N5181A-11A

Information Only Service Note

N5181A MXG Analog Signal Generator

The Problem – The N5180-60024 LCD Assembly is No Longer Available

Figure 2 - LED Backlight Driver Board Connection

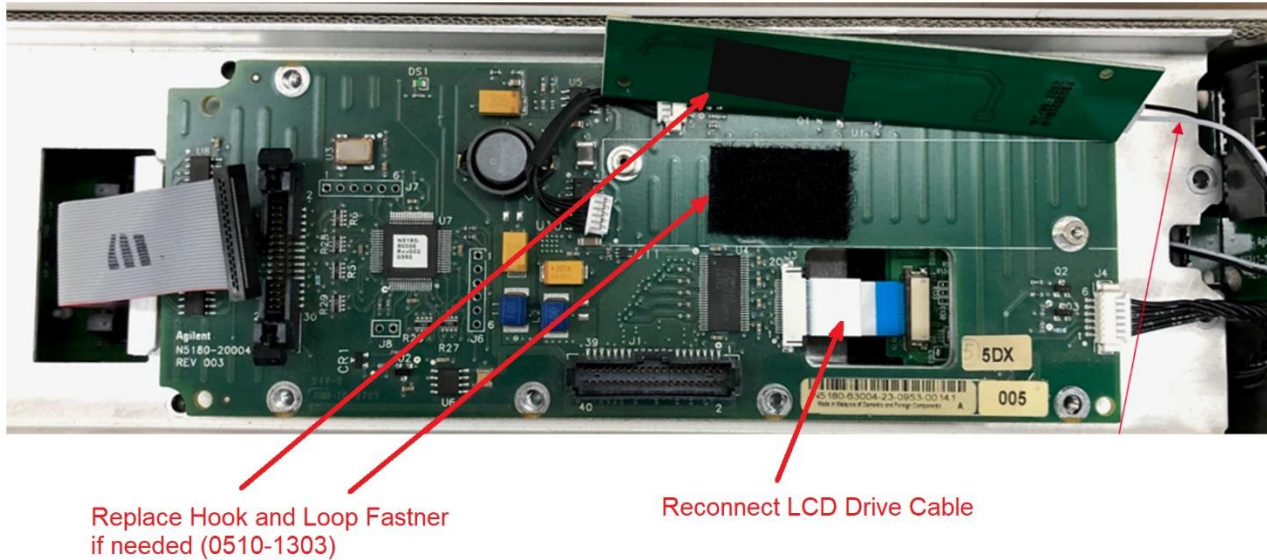
2. Install the replacement LCD into the front frame assembly
3. Install the replacement LED Backlight Driver board using the same location and screws for the original backlight driver board, as shown in Figure 2 and Figure 3

Figure 3 - LED Backlight Driver Board Attachment

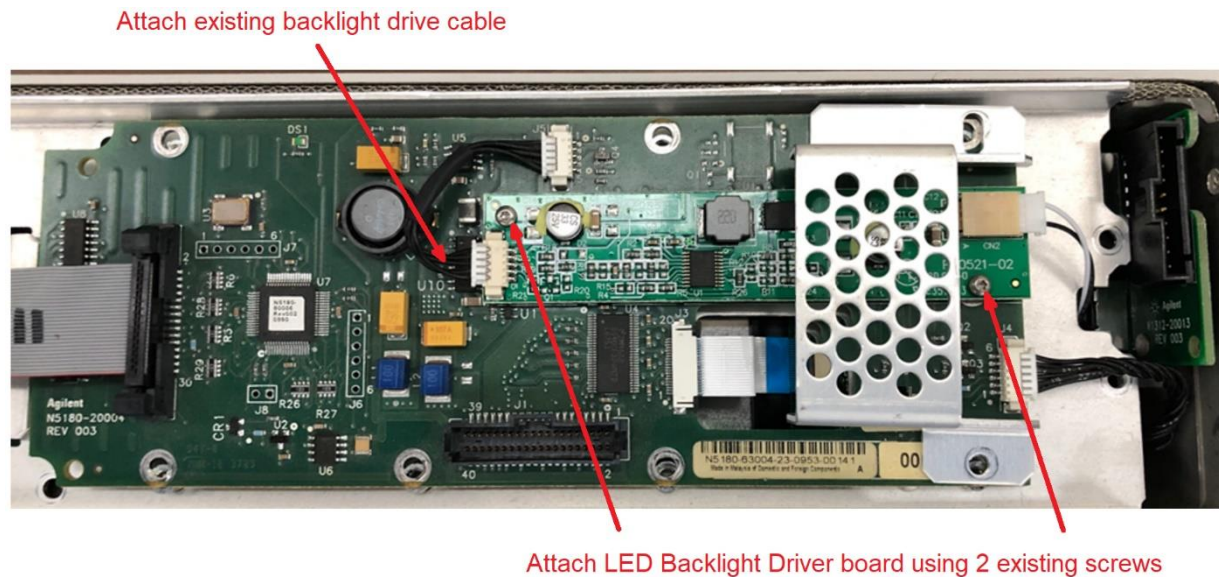
4. Attach the existing backlight drive cable to the new LED backlight driver board, as shown in Figure 3
5. Once the assembly is completed, turn the instrument on and verify operation.
6. If the display needs to be adjusted press **Utility**, **Display** and adjust the **Contrast**, as shown in
